## ADDENDUM

Project: Ragsdale High School Boiler Replacement Project

Addendum Number: 1

Issue Date: January 24, 2024

### BOILER ROOM PARTIAL EQUIPMENT AND PIPING PLAN

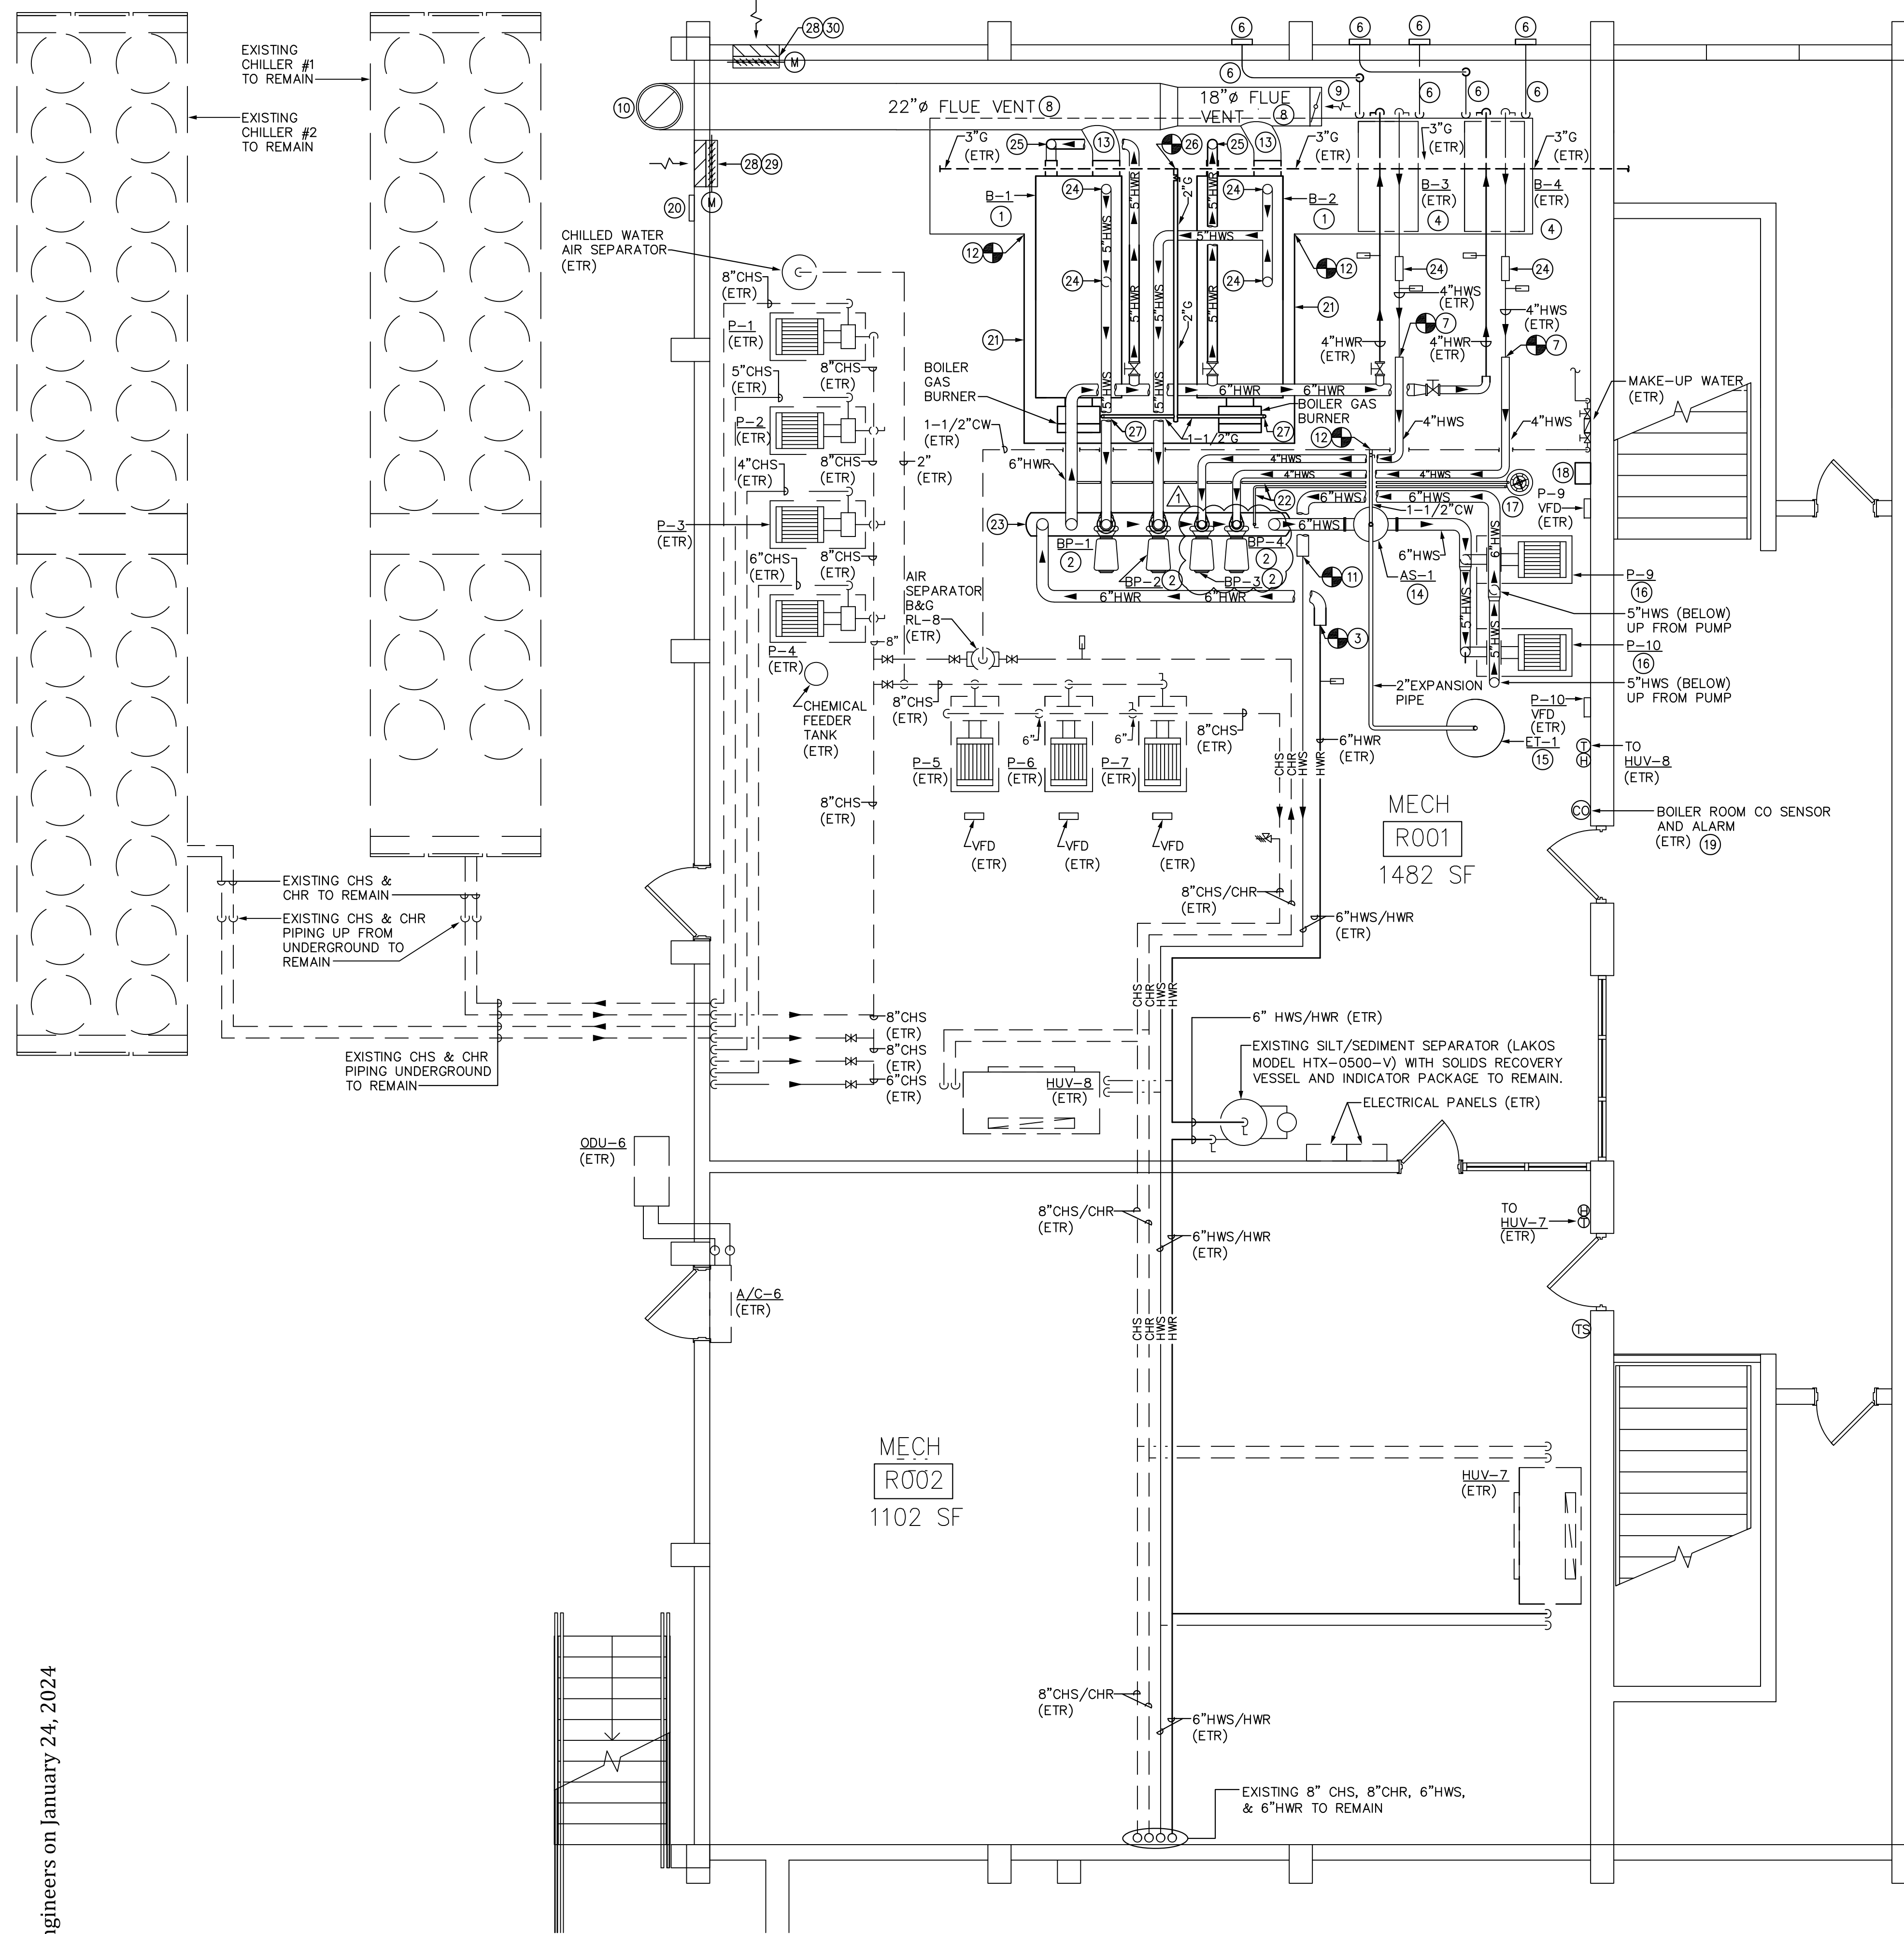
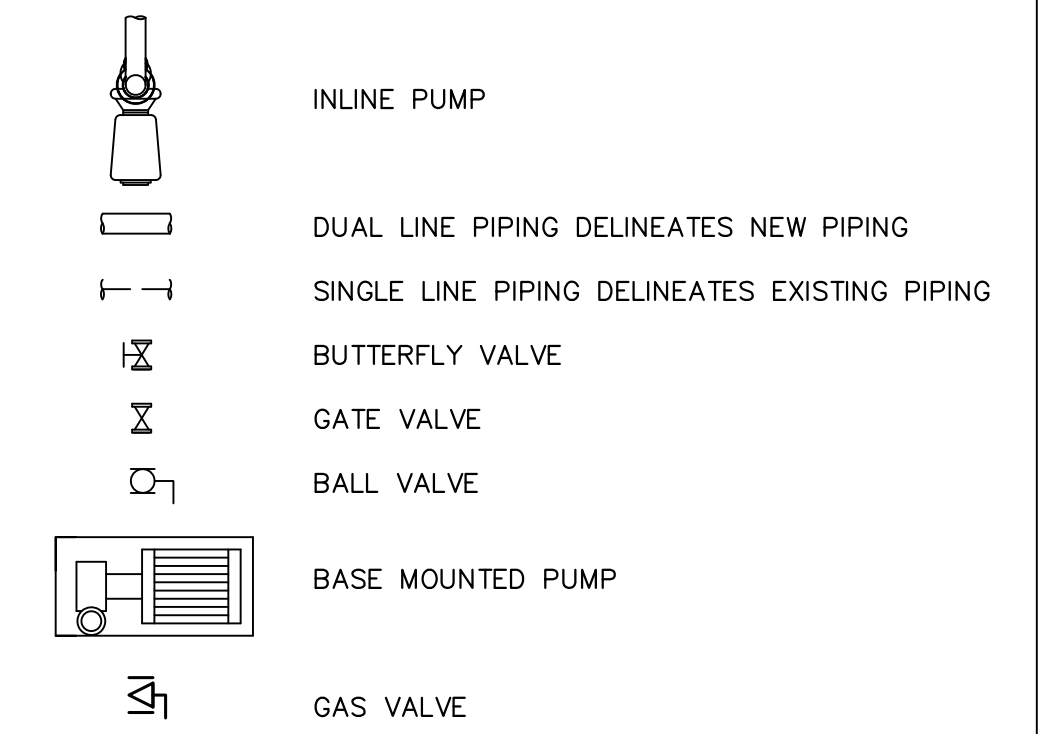
Item No. 1: Sheet M2.1

1. Revisions to pump B-3 and B-4.

**ALTERNATE BID NO. 2: SHOP BUILDING BOILER ROOM PARTIAL EQUIPMENT AND PIPING PLAN**

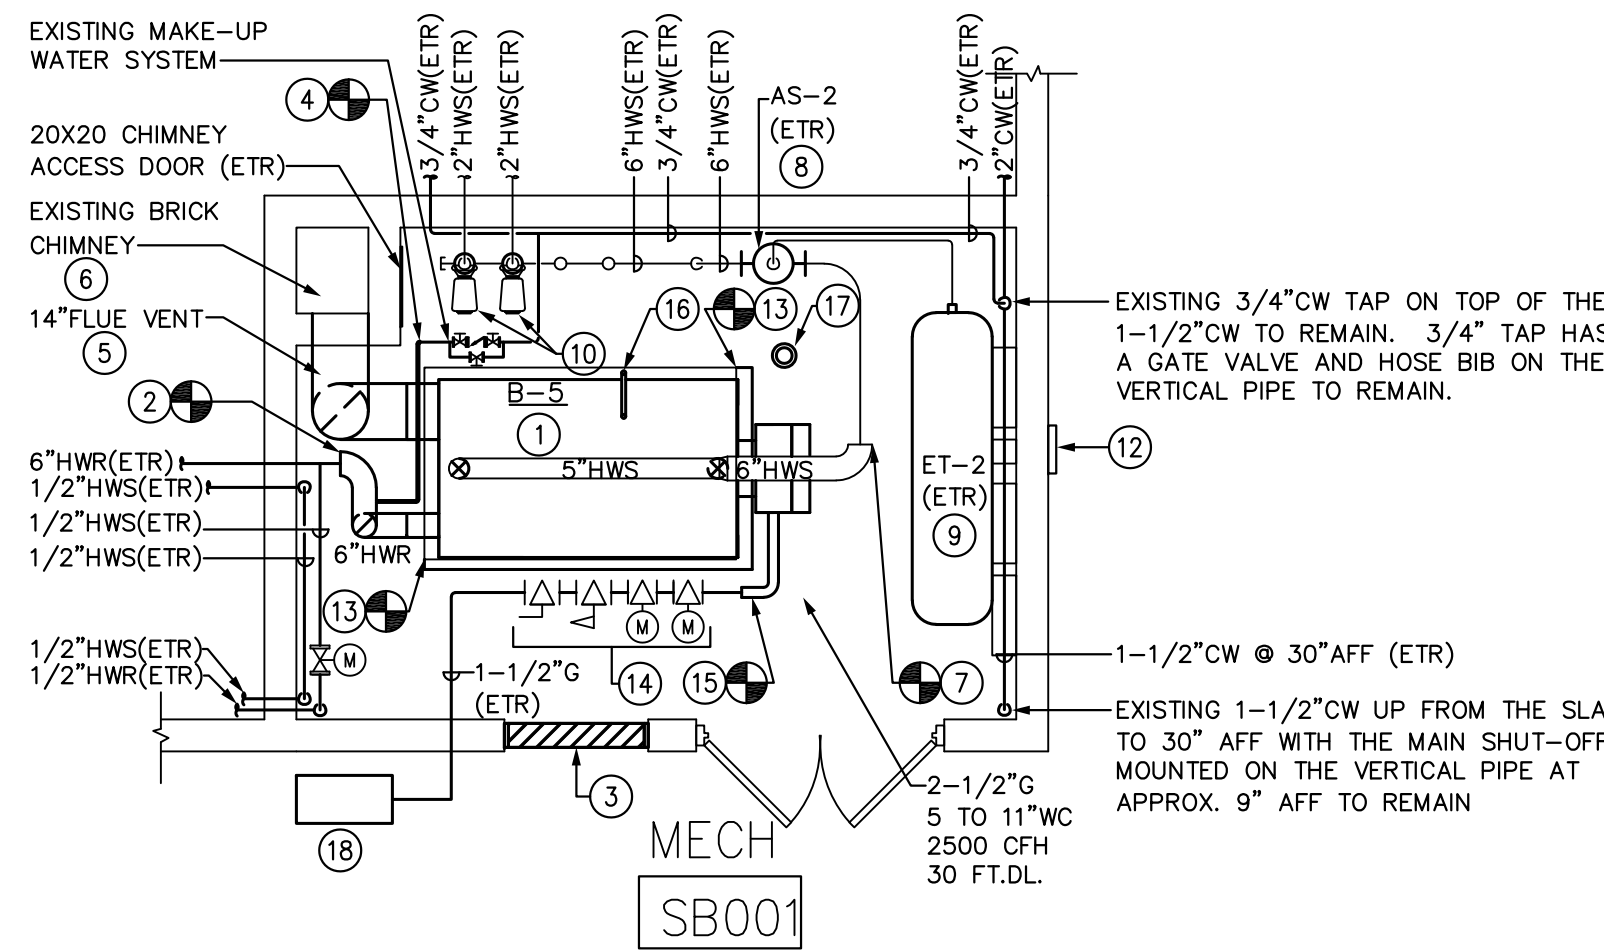
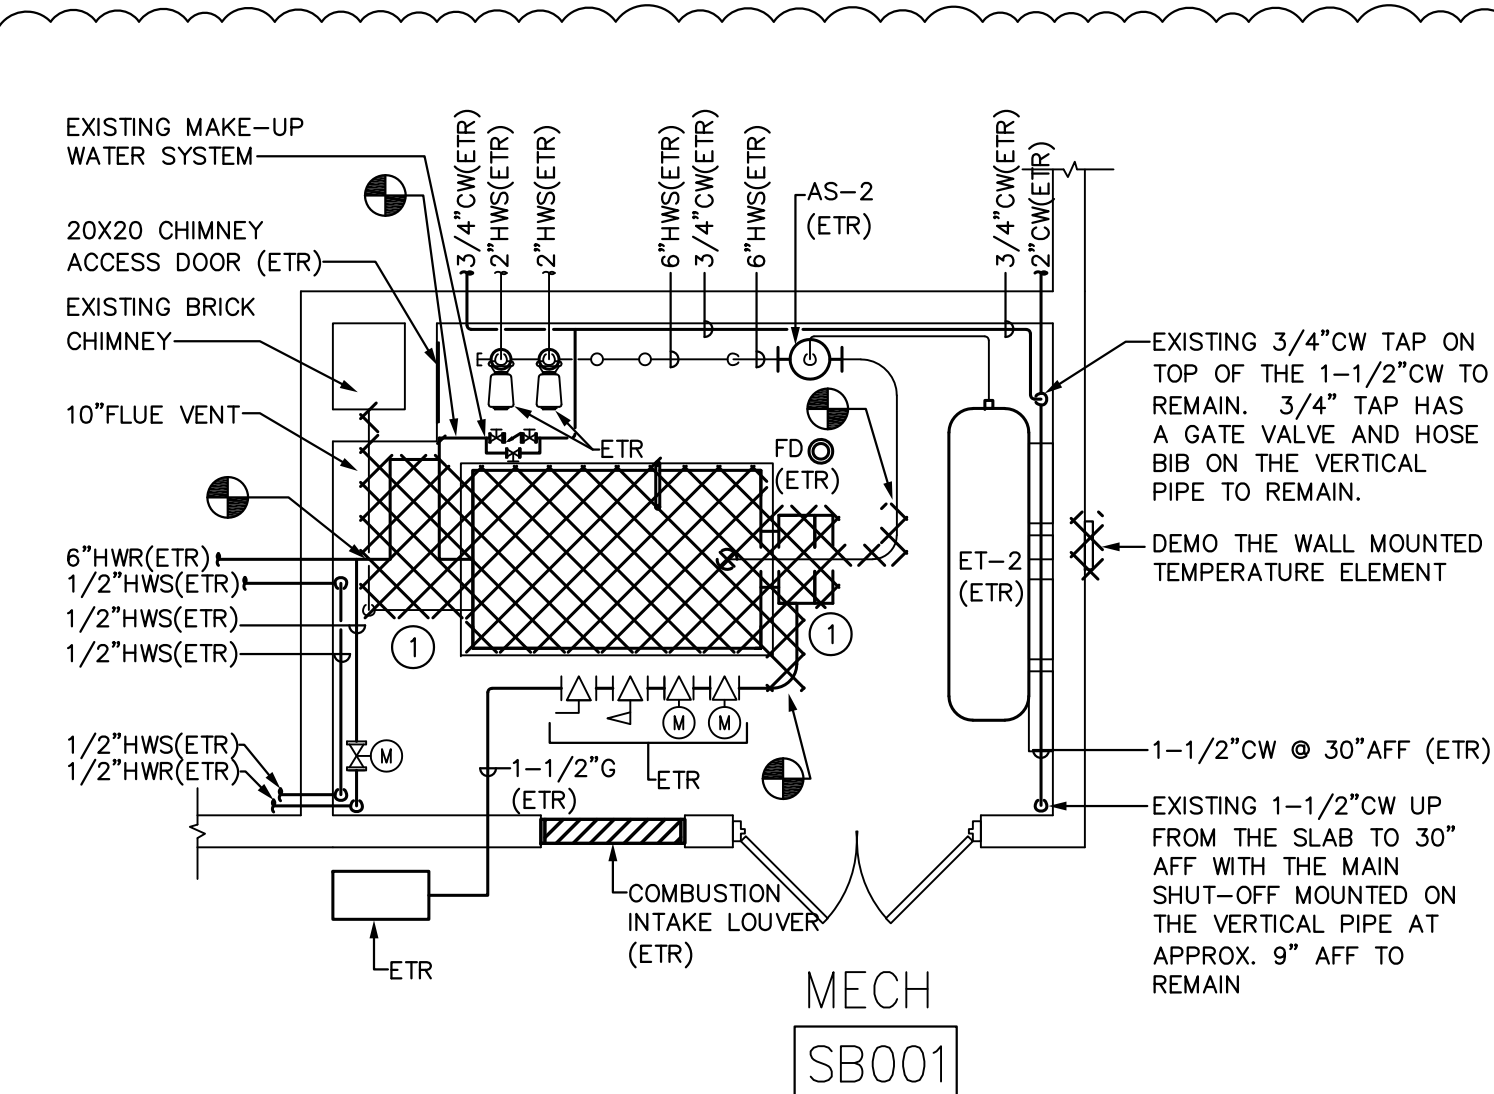
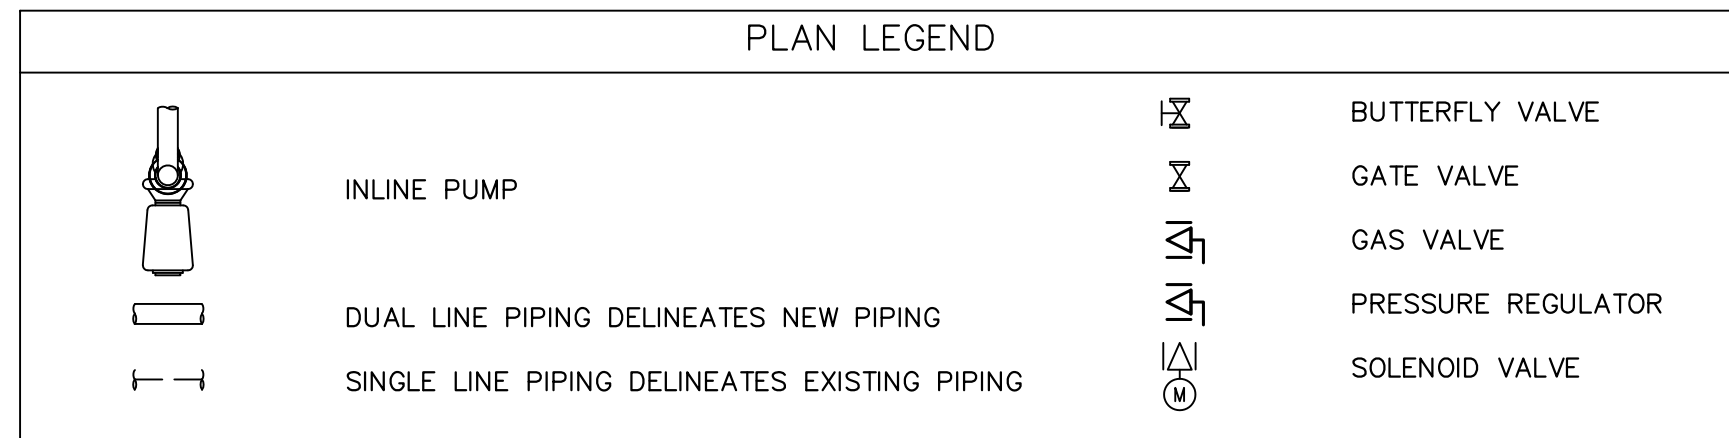
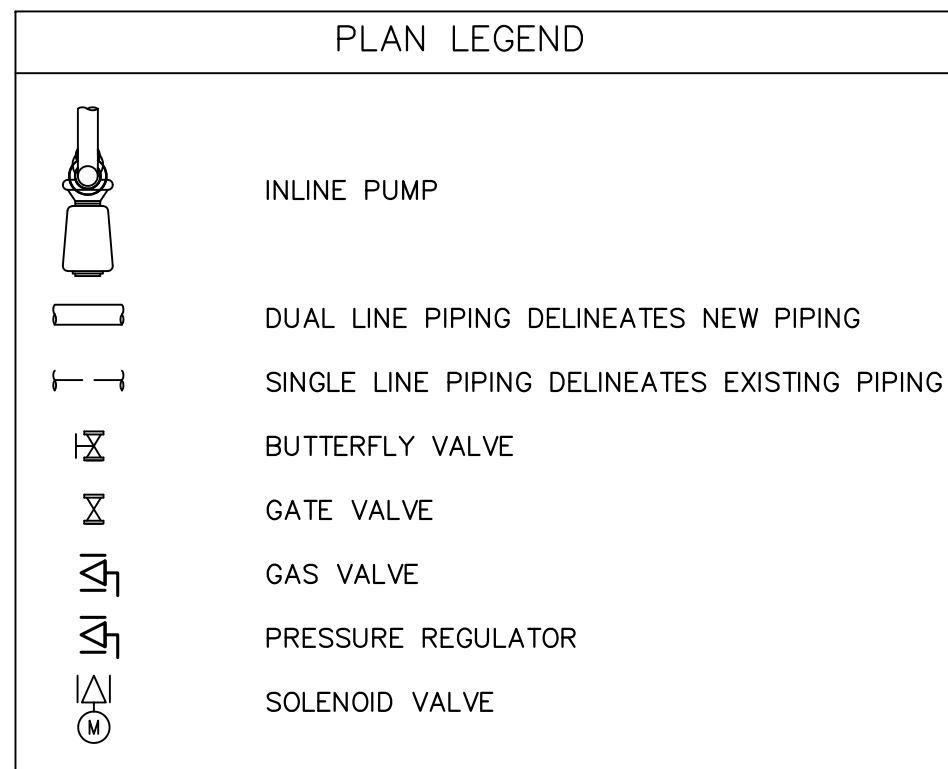
Item No. 2: Sheet M3.1

1. Added plans for the demolition plan and new plan for the Shop Building Boiler Replacement (alternate 2 and 3).
2. Modified the schedules to show boiler, air separator, and expansion tank for the boiler replacement.

DRAWN BY: CDM  
 CHECKED BY: JMB  
 DATE: 1/10/24  
 PROJECT NO. 082423  
 SHEET NUMBER  
**E3.1**

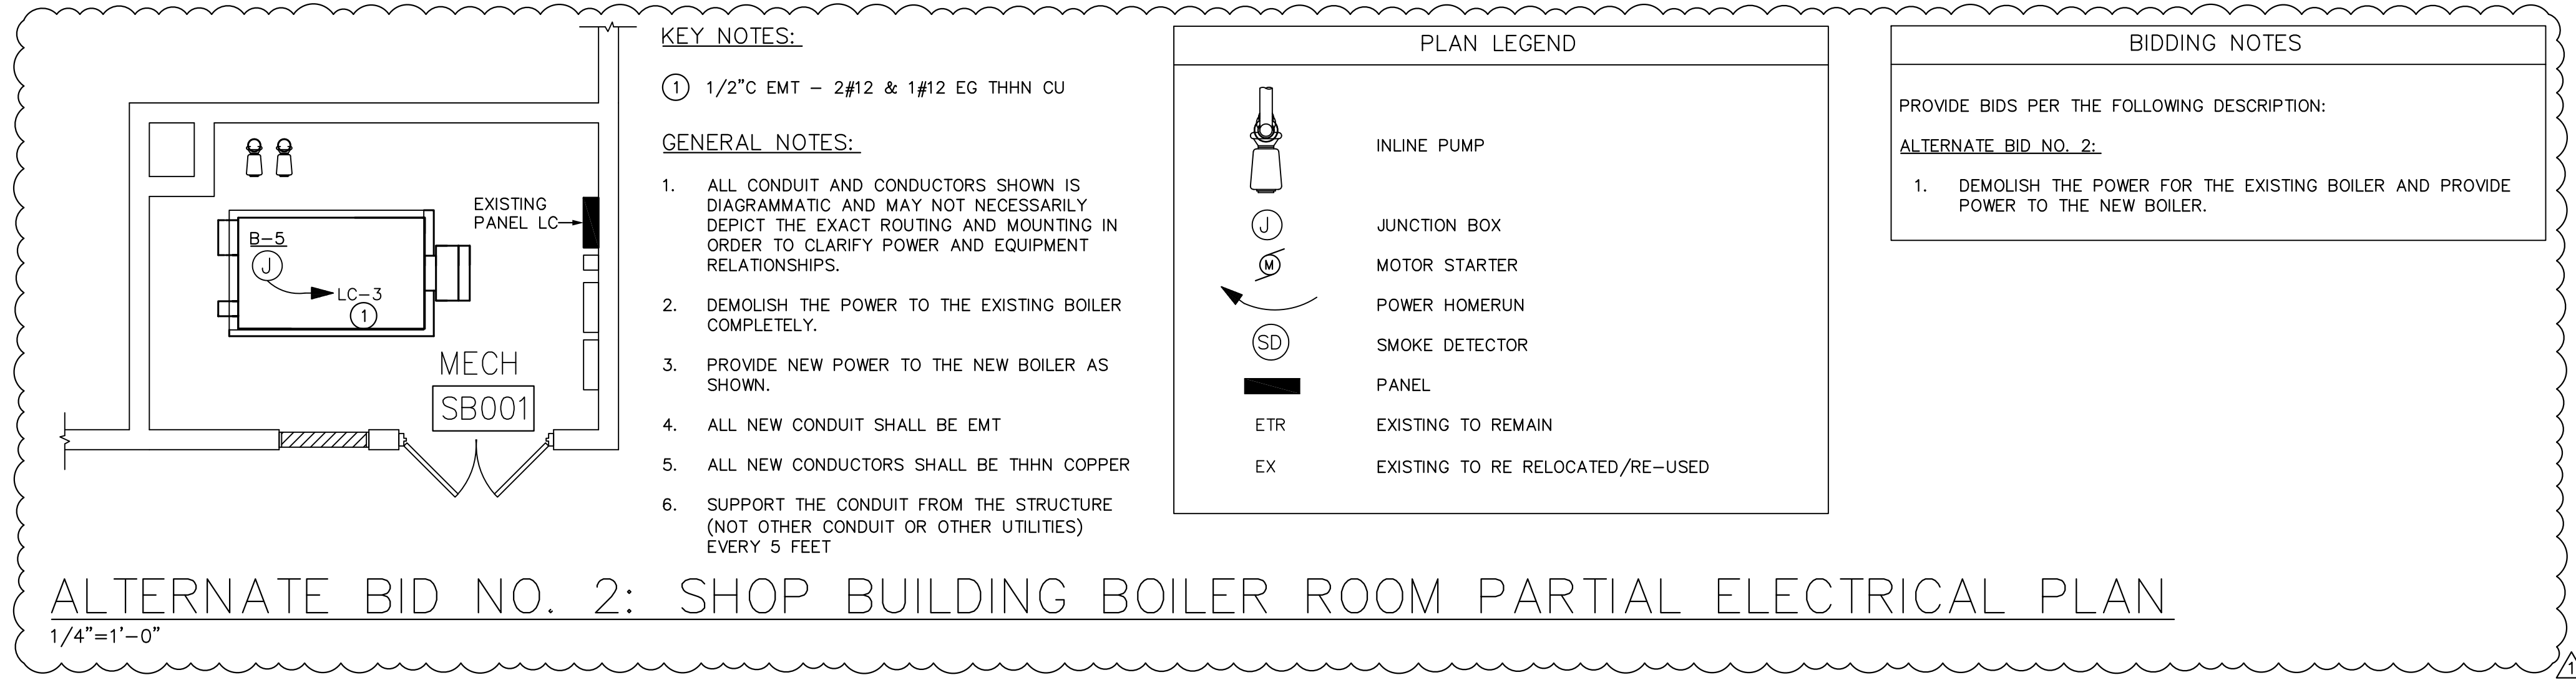
Item No. 3: Sheet E3.1:

1. New sheet that shows power for the shop building boiler.
